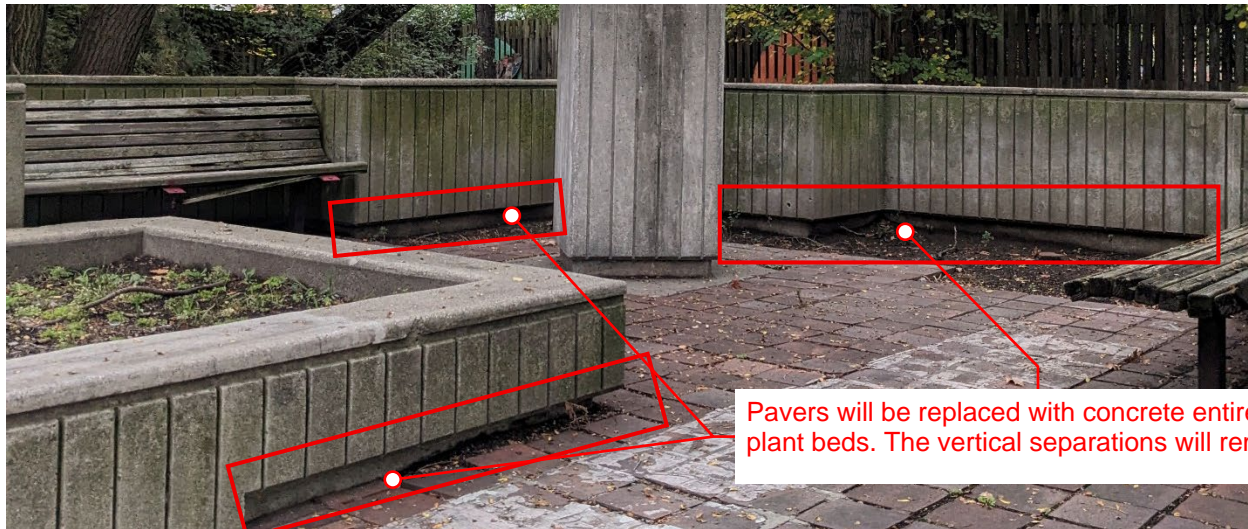
At the bust, will the platform retain its footprint once the brick pavers are replaced with concrete? There is currently a separation between the vertical concrete elements, and the floor surface, giving a sort of floating illusion. Can you confirm that this feature will remain?

Pavers will be replaced with concrete entirely; no plant beds. The vertical separations will remain.

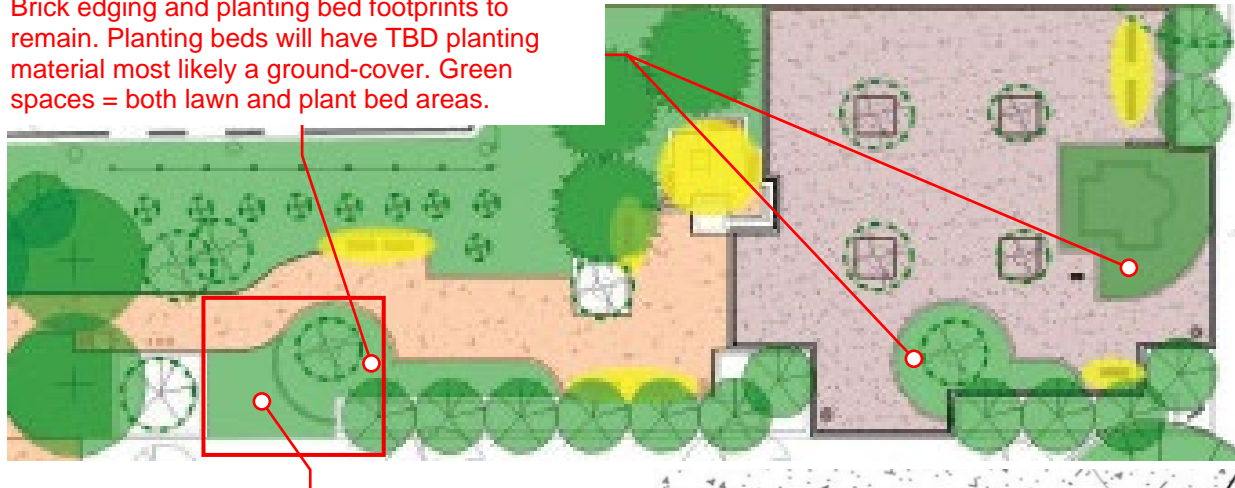
I saw that you highlighted the areas with brick edging as proposed greenspace. Does this imply the brick will be surrounded by grass? How will this be maintained over time?

What do these lines imply? Please specify the material. 1' wide brushed concrete edge

Please reconfirm material designated for the main ground surface, as well as the material for the continued pathway: Plaza area is a compacted crushed limestone surface and other pathways will be concrete

Brick edging and planting bed footprints to remain. Planting beds will have TBD planting material most likely a ground-cover. Green spaces = both lawn and plant bed areas.

Planting bed/brick edging will be adjacent to and surrounded by grass which will be mowed regularly

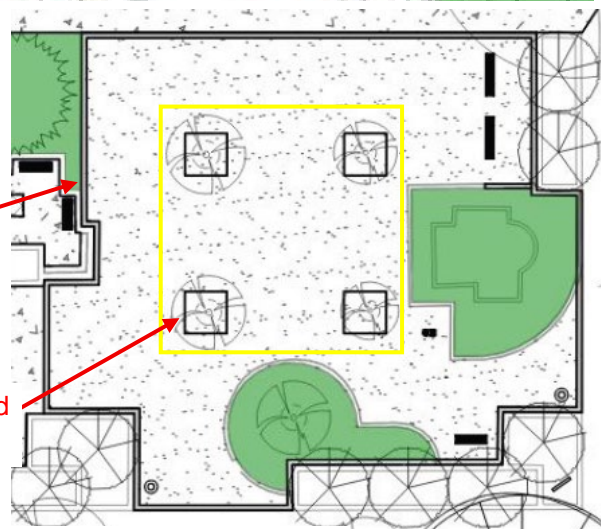
Please confirm materiality of all borders, including these tree openings

The lines bordering the trees are a drawing error; the plaza will be a compacted crushed limestone surface bordered by brushed concrete edge as specified in package and remaining surfaces in the park will be concrete
